Land Use Committee Report

City of Newton In City Council

Tuesday, May 12, 2020

To: Neil Cronin, Jennifer Caira – City of Newton
From: Janet Carter Bernardo, PE – Horsley Witten Group, Inc.
Date: May 8, 2020
Re: Riverside Station – Peer Review Comments Regarding Recent Plan Changes

Hotel Green: Comparison

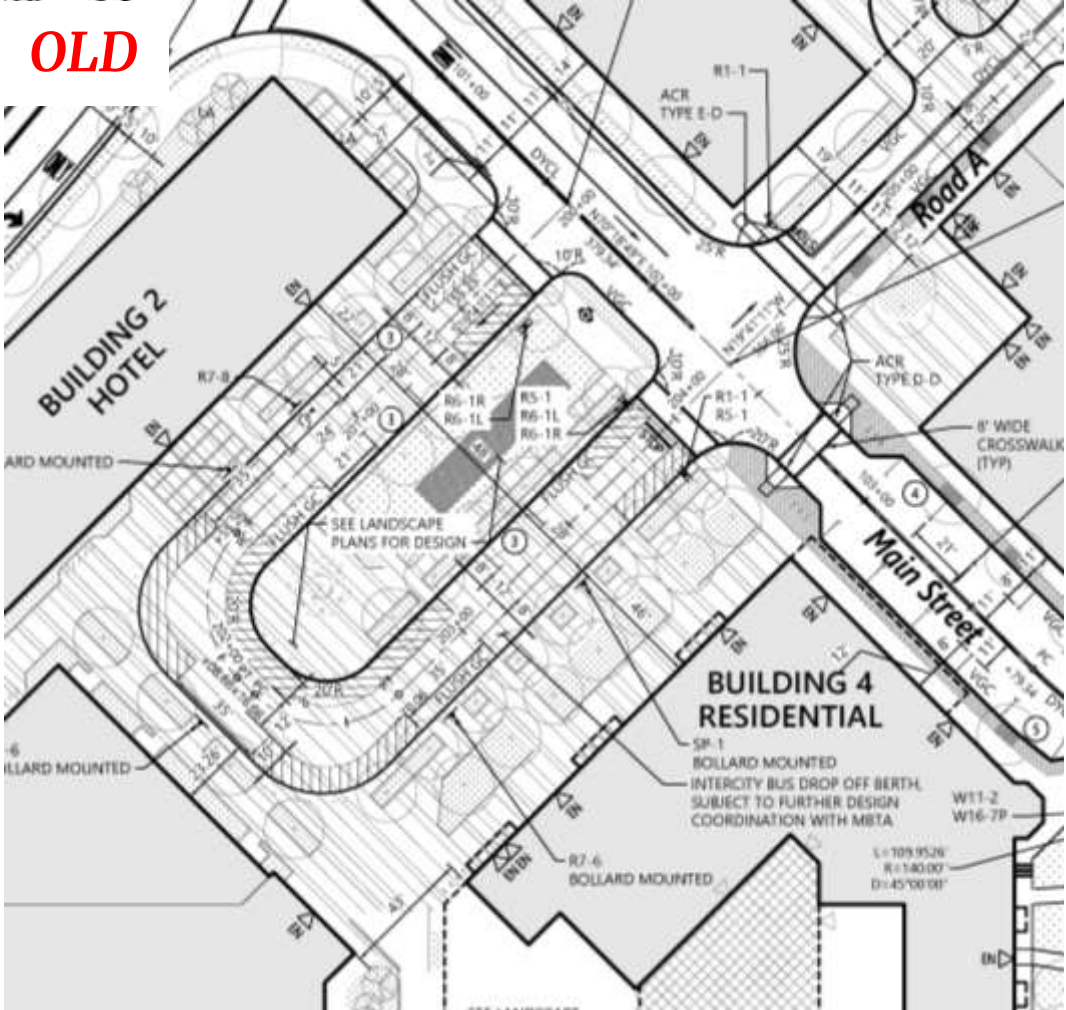
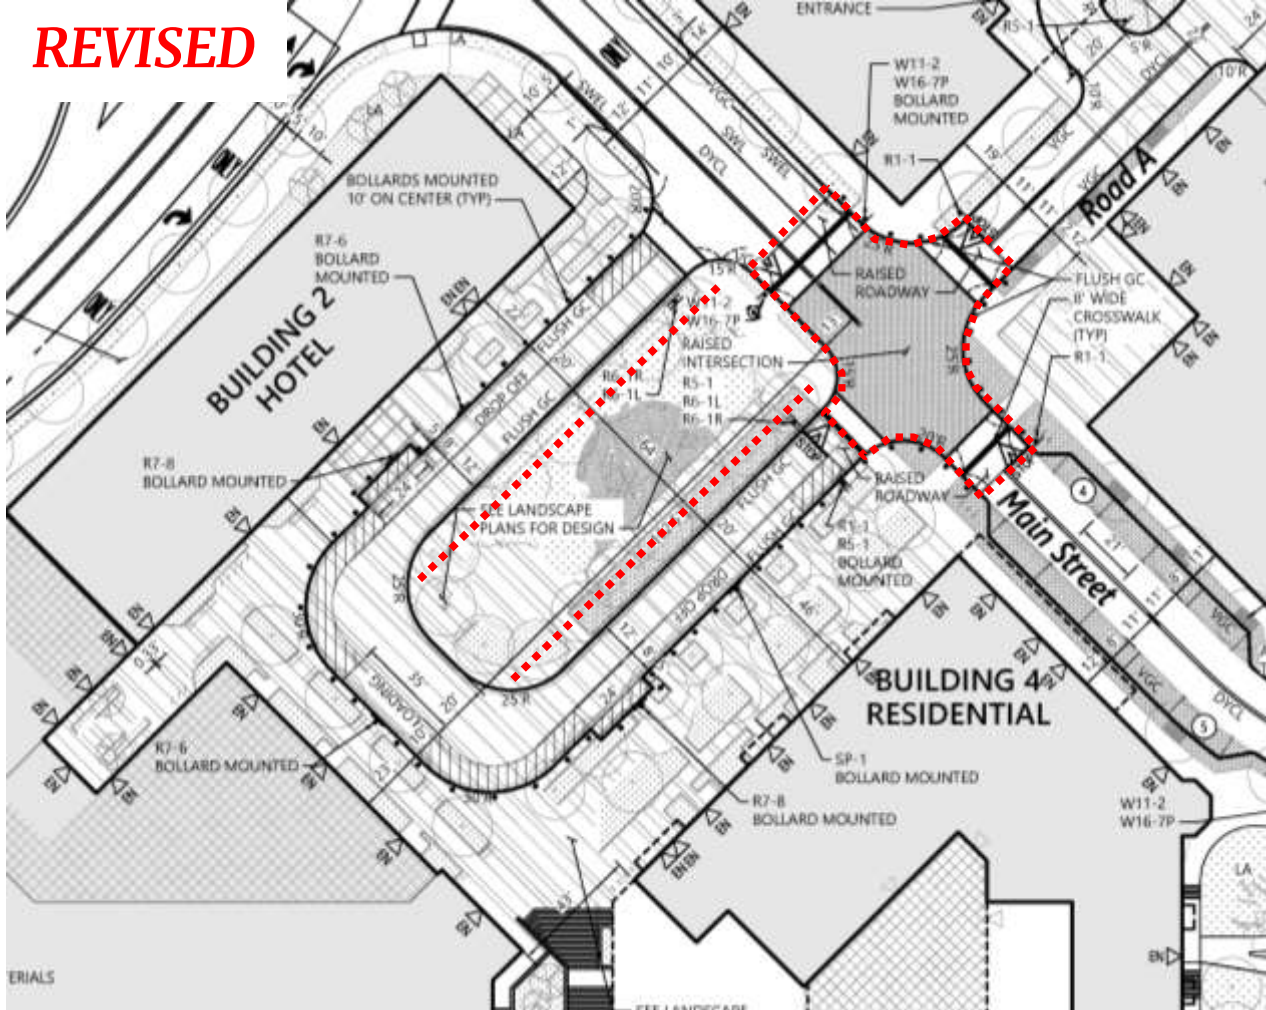
1. Inner parallel parking removed from Green expands beneficial space.
2. Removal of bocce court is offset by added playspace and bioretention.
3. Raised Main Street intersection & crosswalks improve value of Hotel Green & Building 10 plaza, and provide traffic calming.
4. Building 10 plaza requires more clarification as part of consistency review.

Hotel Green – Summary

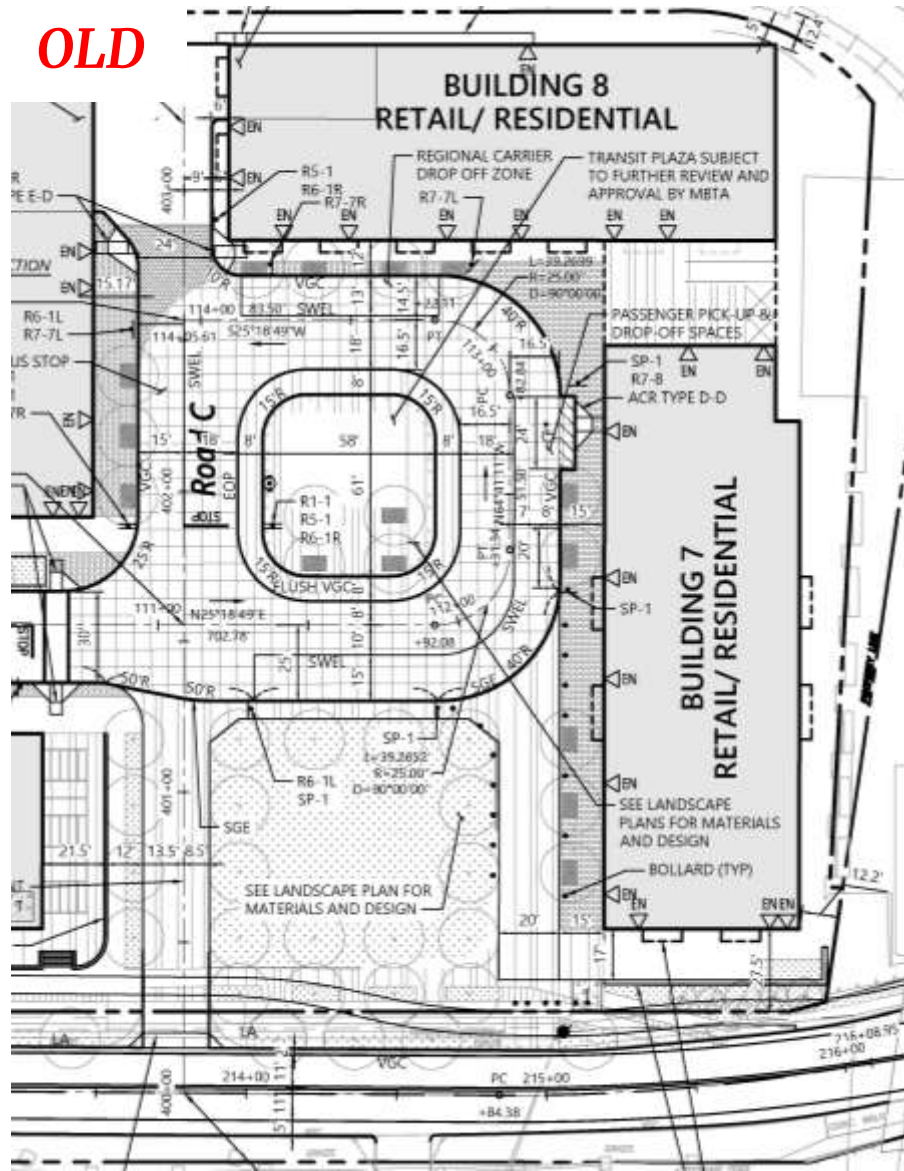
1. Play equipment added to Amphitheater Green.
2. Building 3 Grove Street entry design needs clarification.

Transit Square & Green

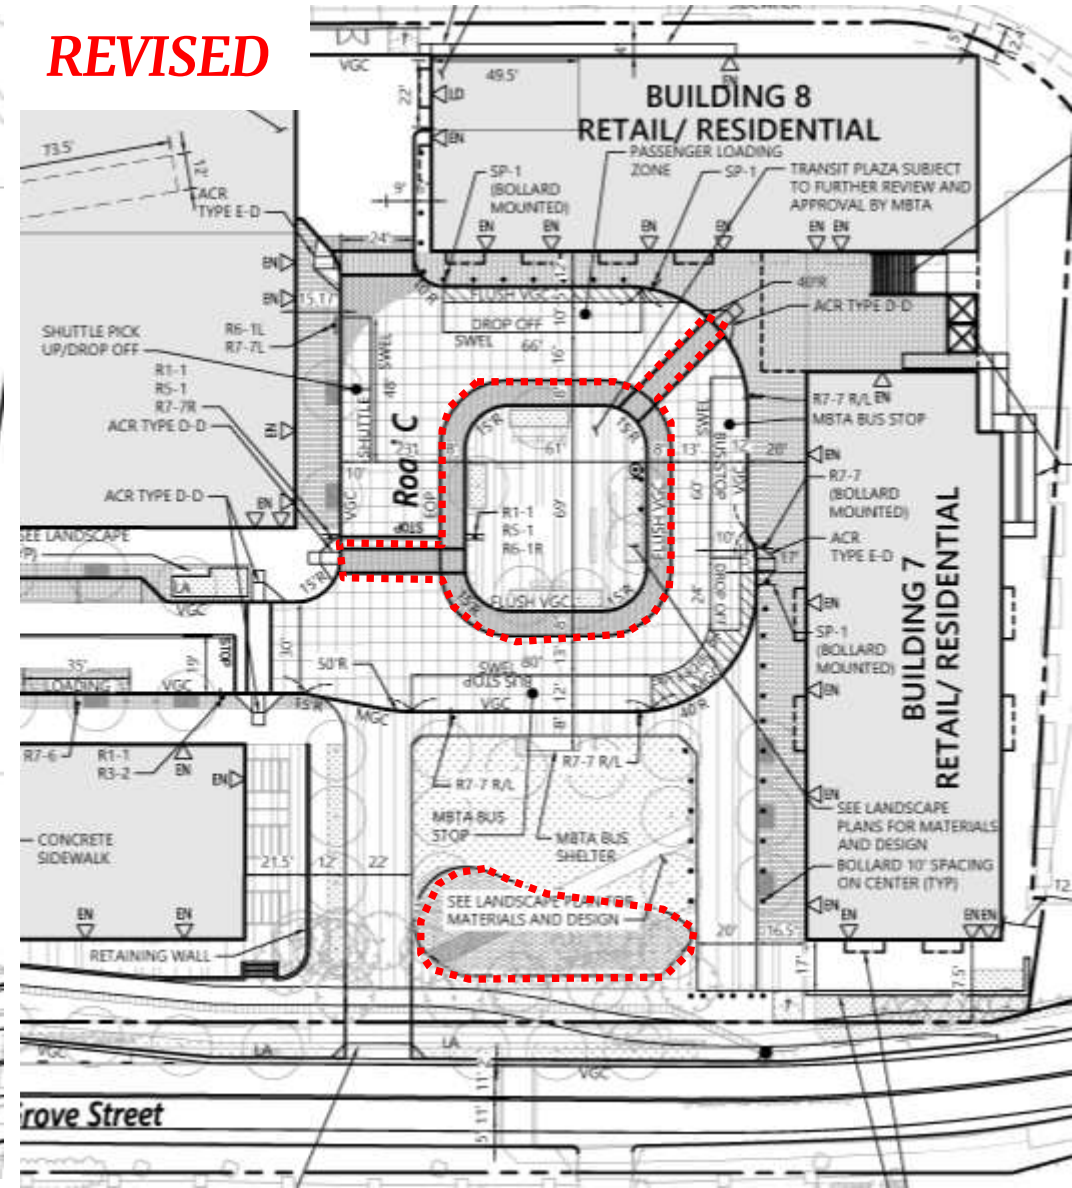
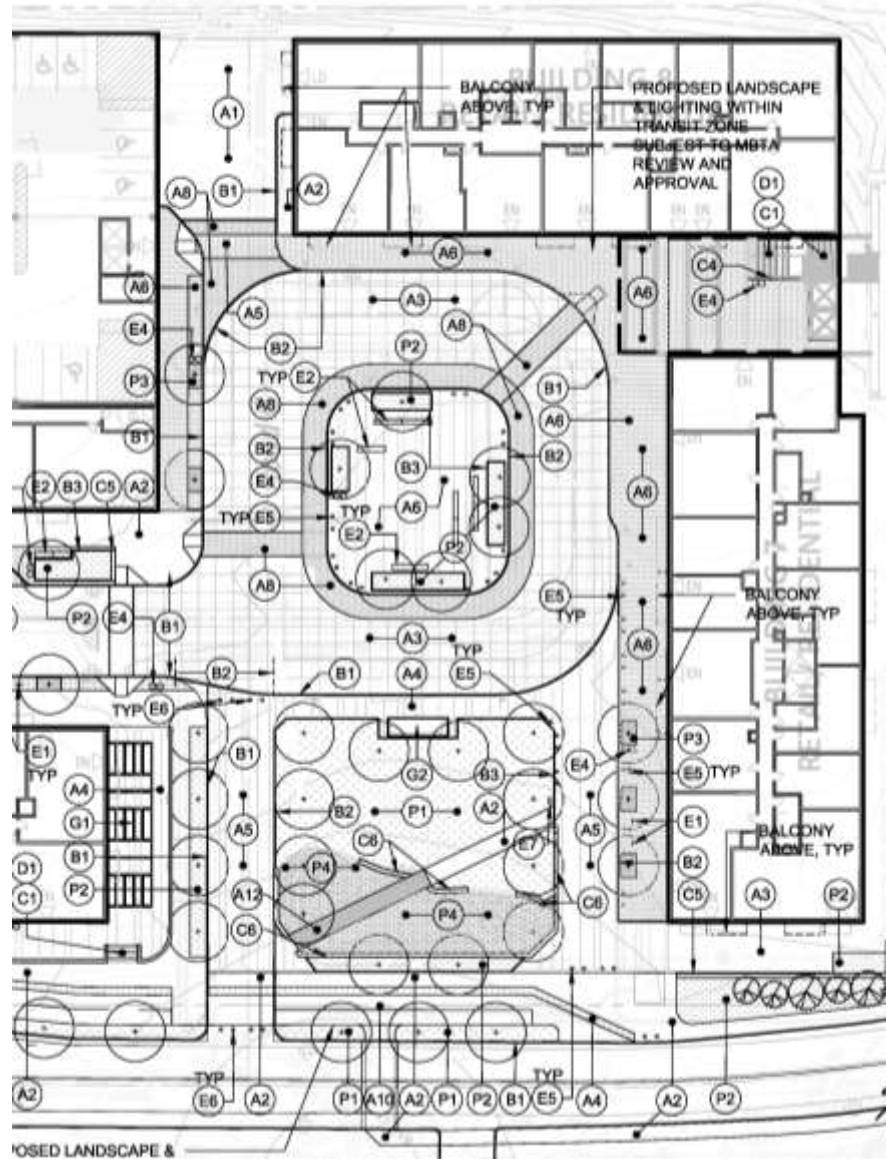
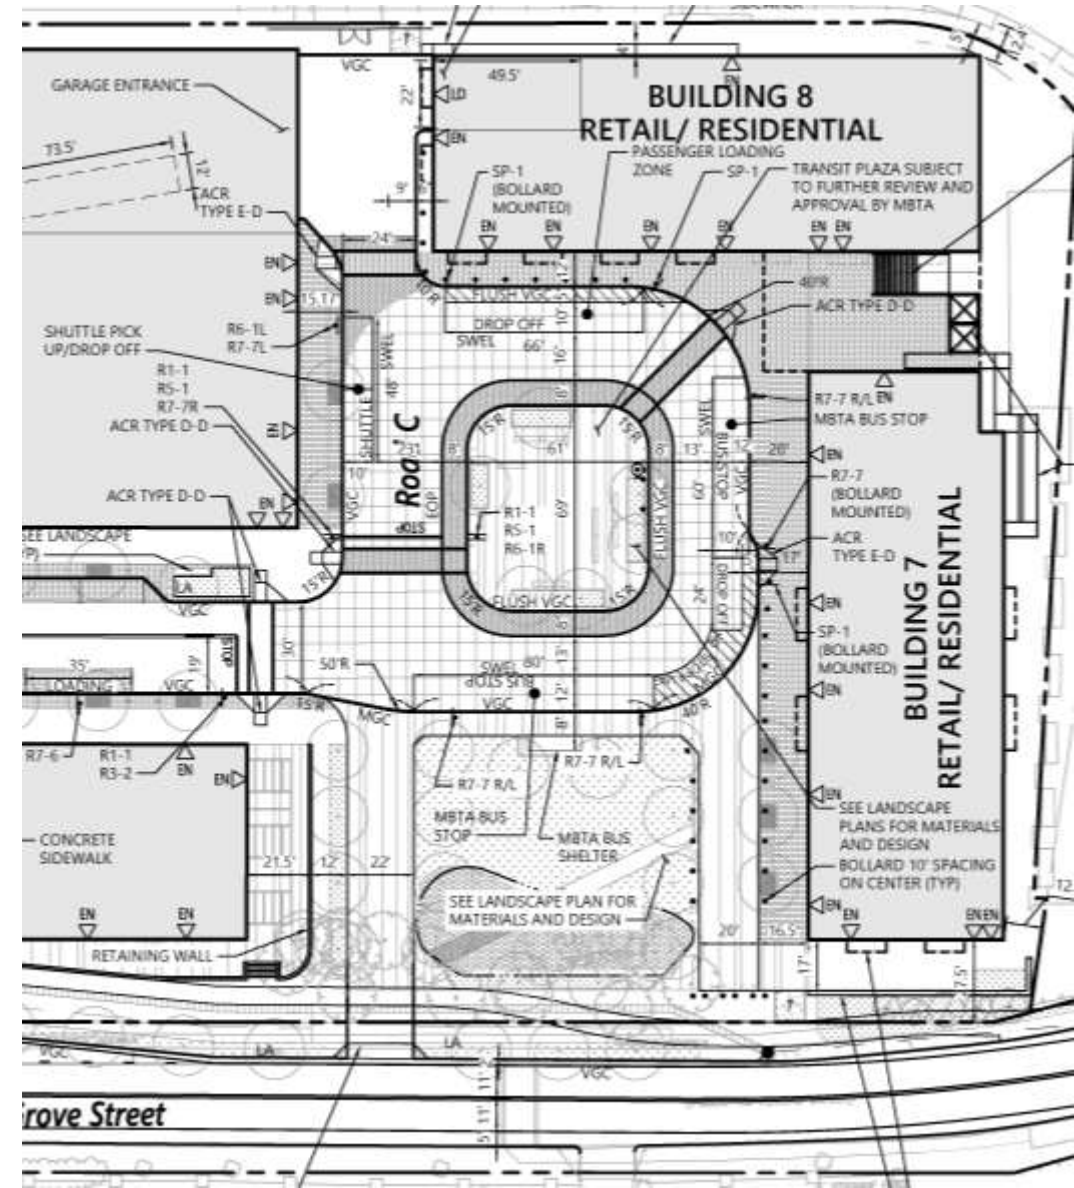
1. **Square: bike pavilion removed, bike parking moved to Building 7.**
2. **Square: seating and plantings added.**
3. **Green: bus shelter added – will help activate the space and integrate with the Square.**
4. **Green: bioretention added – benefits of bioretention must be balanced with usability of open lawn area.**
